**ADDENDUM
NO. 4**

**Greenfield Central High School Auditorium Renovation and
Addition – Bid Package No. 1
810 N. Broadway
Greenfield, IN 46140**

ADDENDUM NO. FOUR

1 ENLARGED AUDITORIUM BALCONY FRAMING PLAN
3/16" = 1'-0"

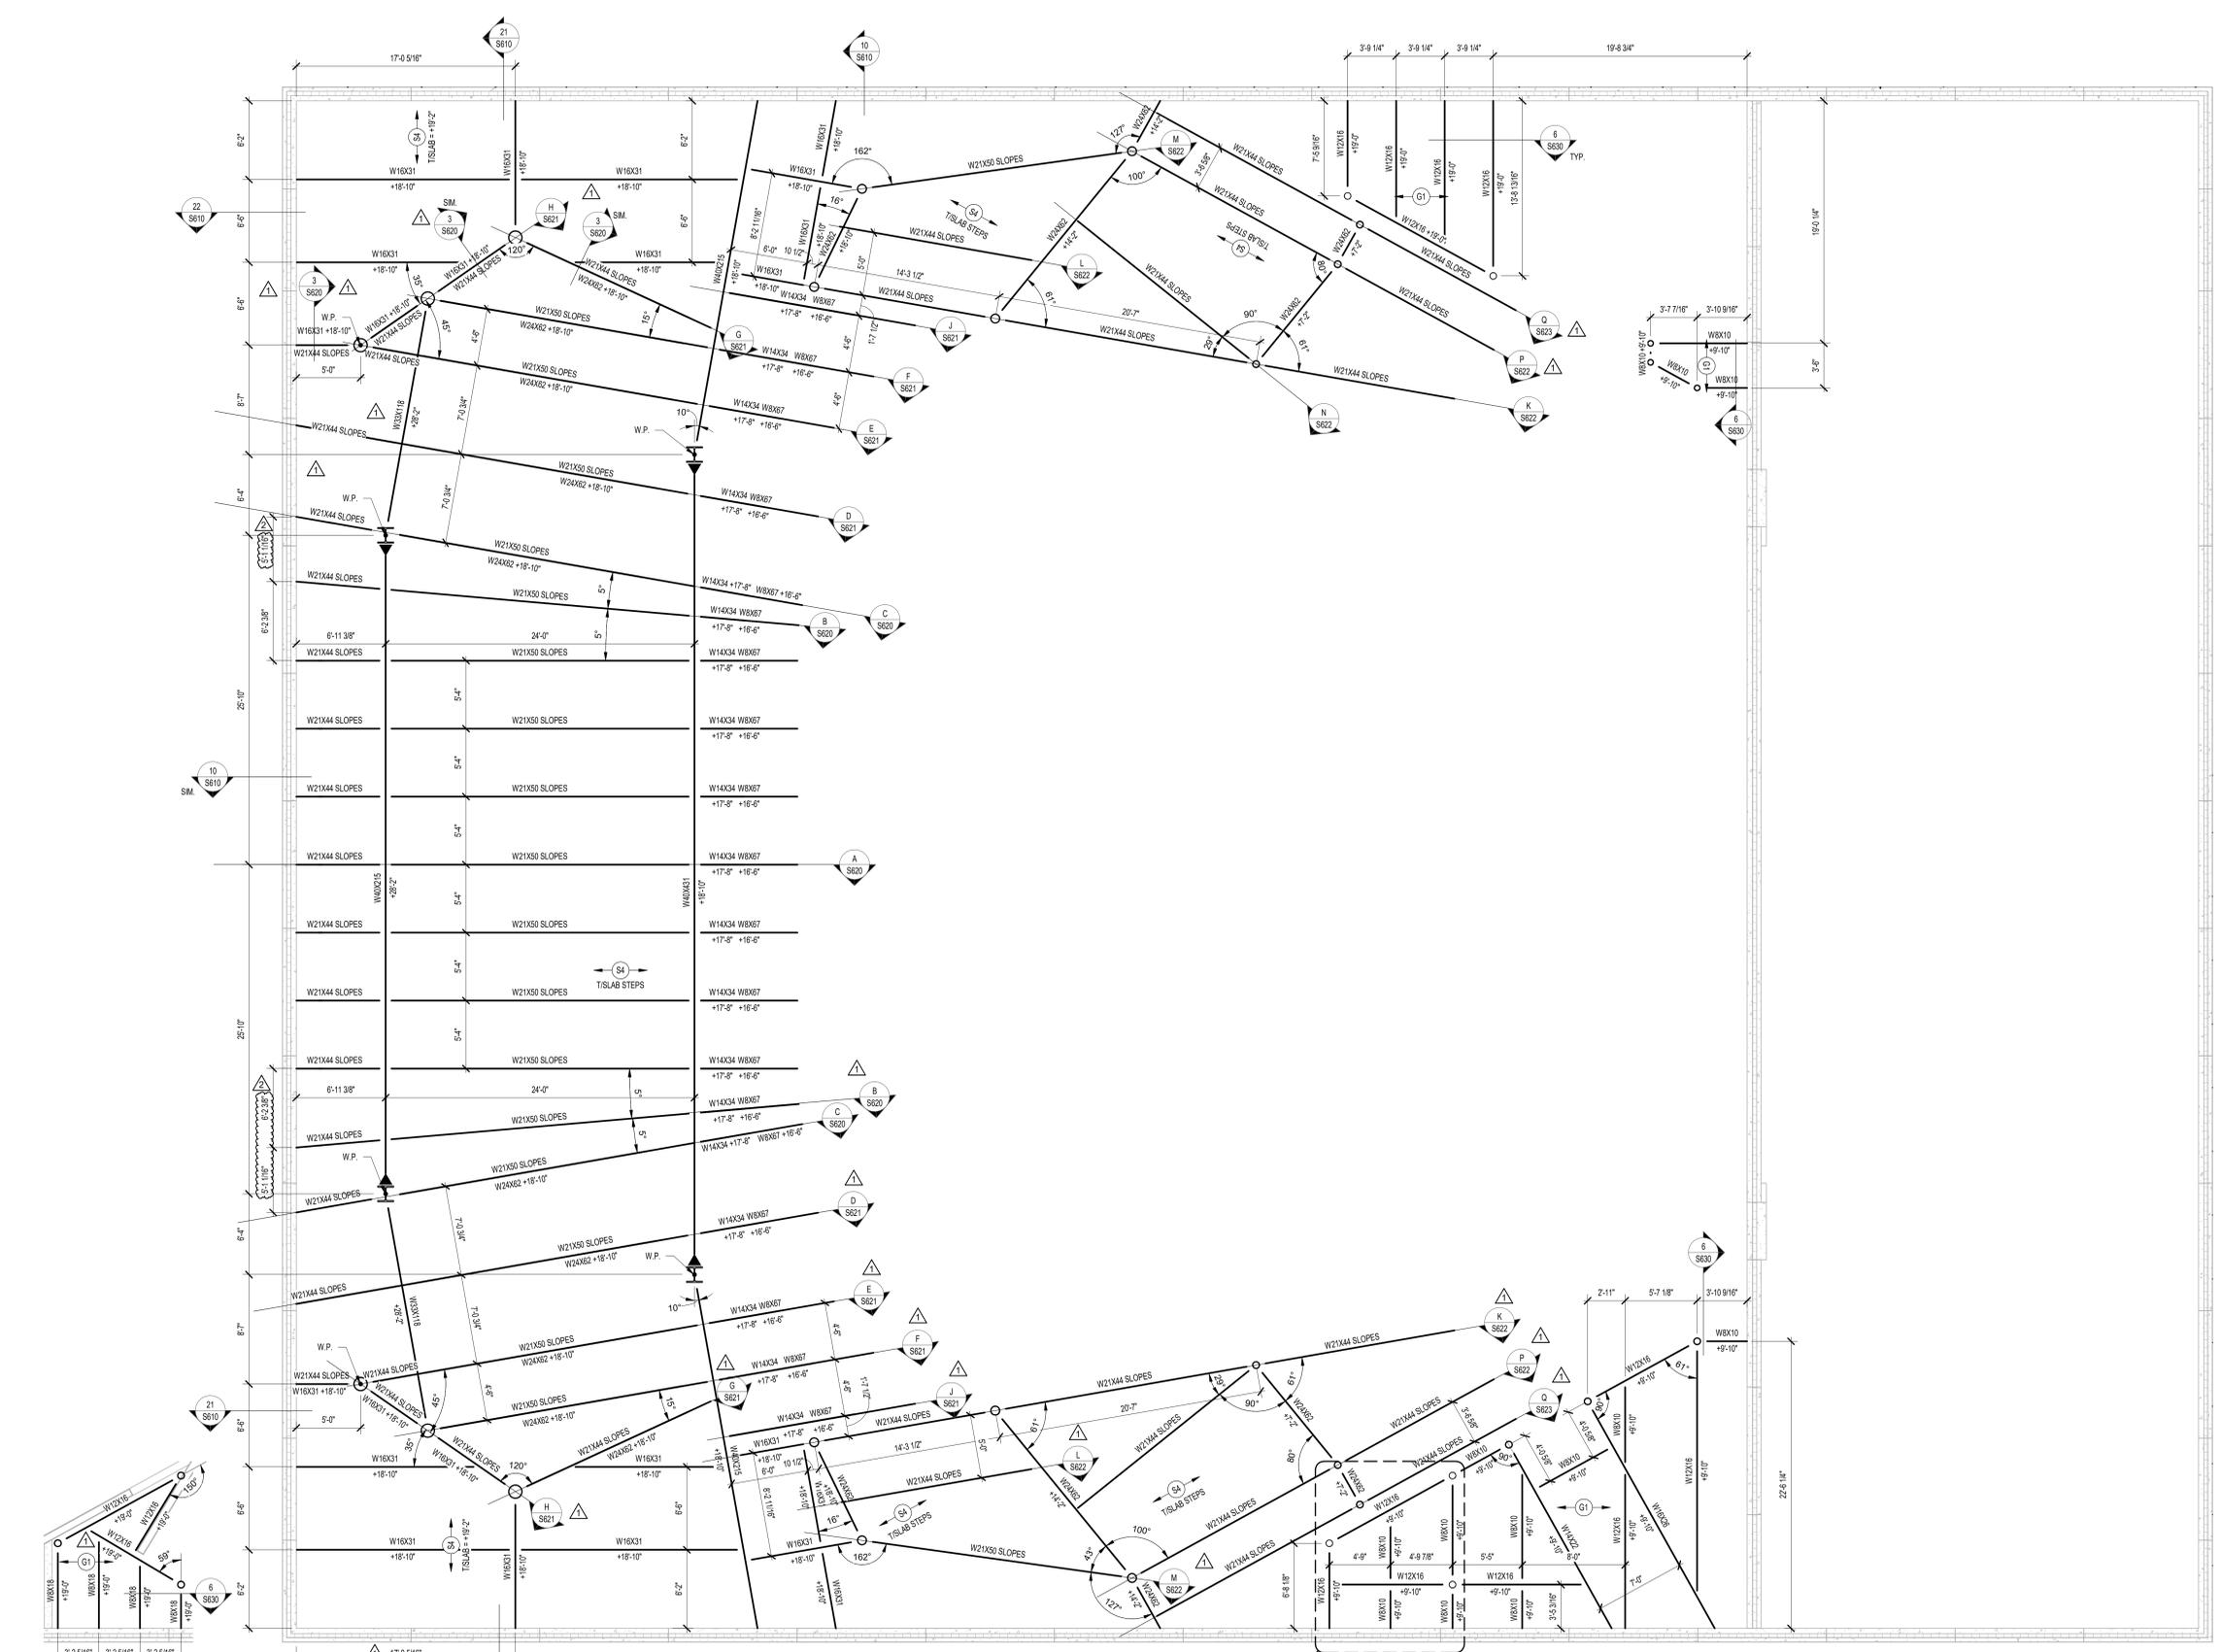
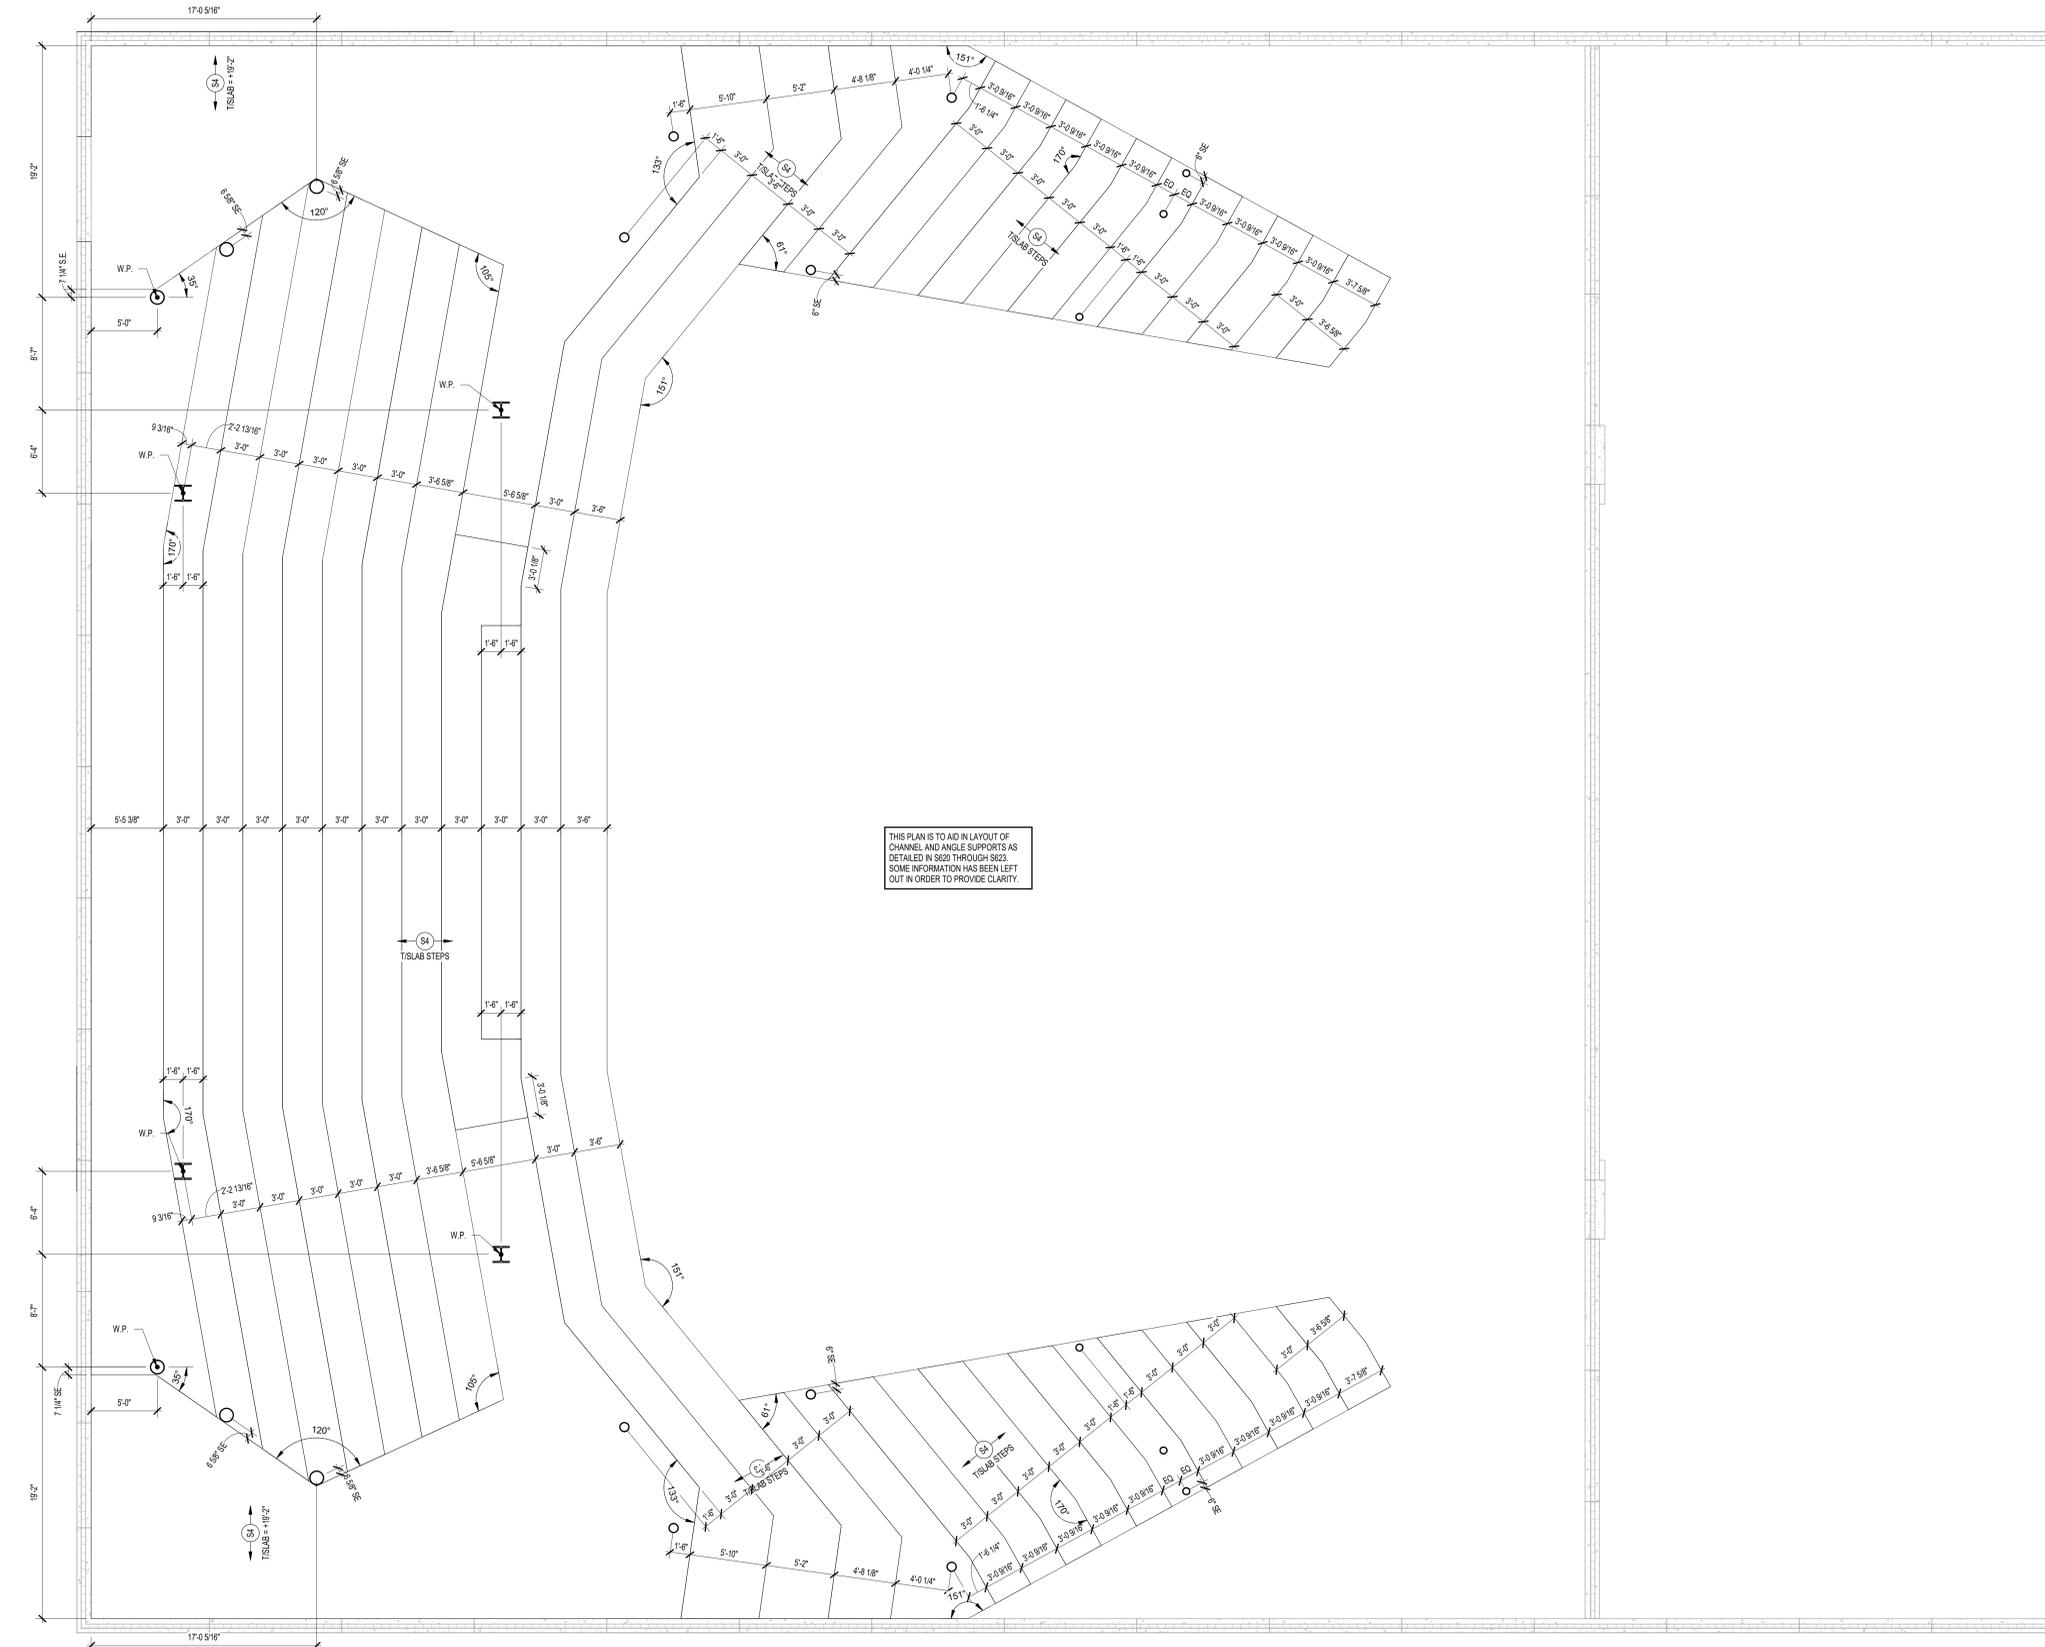
6. S202 – ENLARGED AUDITORIUM BALCONY FRAMING PLAN
 - a. ADDED DIMENSIONS DEFINING BALCONY FRAMING GEOMETRY
7. S202D – ENLARGED AUDITORIUM BALCONY FRAMING PLAN

ENLARGED BALCONY SLAB DIMENSION PLAN

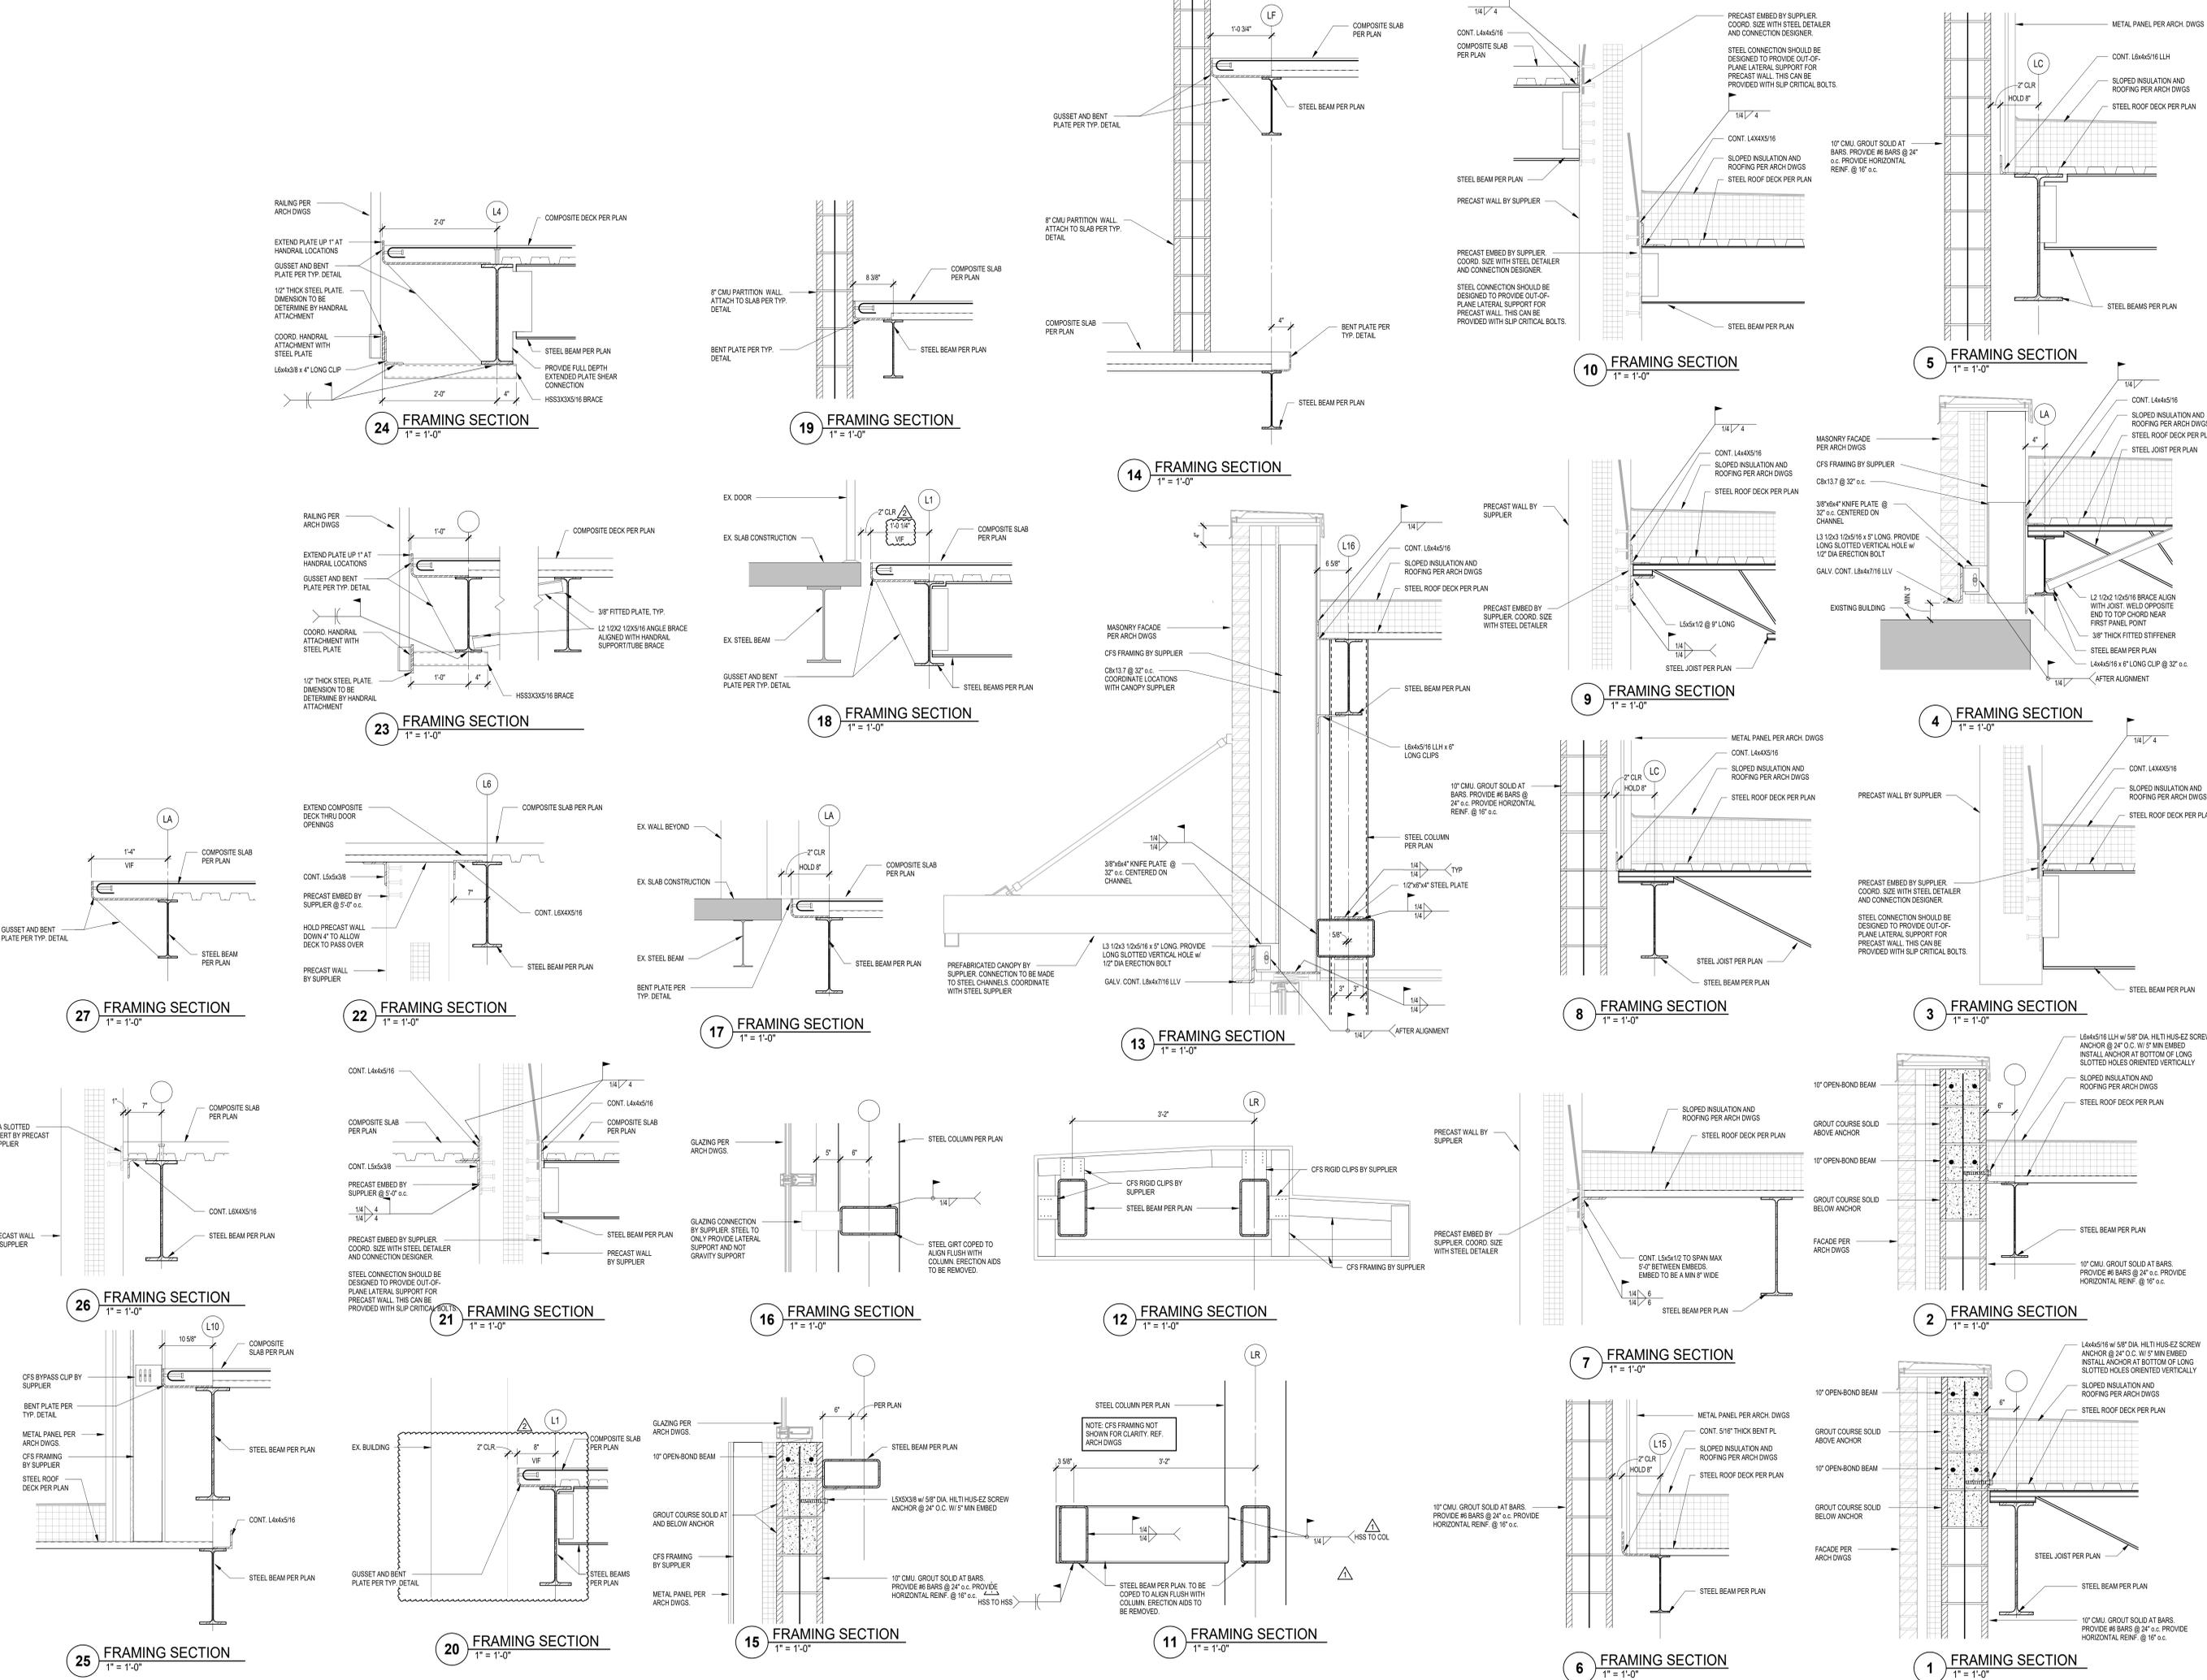
- a. ADDED NEW PLAN DEFINING BALCONY SLAB GEOMETRY
8. S610 – FRAMING SECTIONS
 - a. ADJUSTED DETAIL 18 & 20
9. S611 – FRAMING SECTIONS
 - a. ADDED DETAILS 5 & 6
